S1C17 Manual errata

ITEM: Package			
Object manuals	Document codes	Items	Pages
S1C17653 Technical Manual	412355800	Table 1.1.1 Features Shipping form 1	1-2
		1.3.1 Pin Configuration Diagram	1-3
		1.3.2 Pin Descriptions	1-5
		24 Package/Chip	24-1
S1C17656 Technical Manual	412745100	Table 1.1.1 Features Shipping form 2	1-2
		1.3.1 Pin Configuration Diagram	1-5
		1.3.2 Pin Descriptions	1-6
		24 Package	24-1

S1C17 Family Technical Manual Errata

Figure 24.1 TQFP14-80pin Package Dimensions

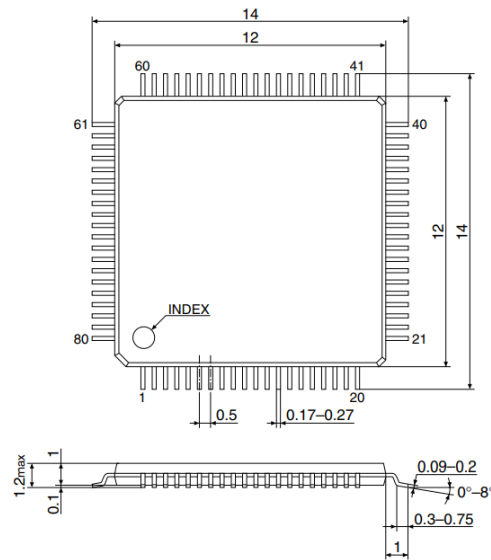
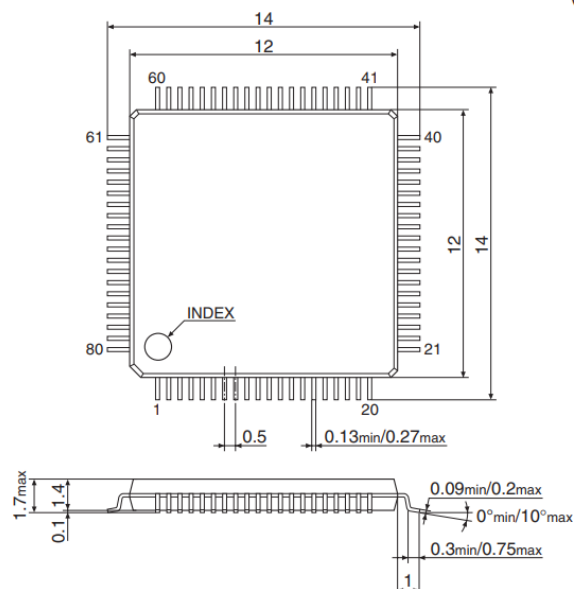
(Error) **24 Package**

TQFP14-80pin

(Correct) **24 Package**

QFP14-80pin

Figure 24.1 QFP14-80pin Package Dimensions
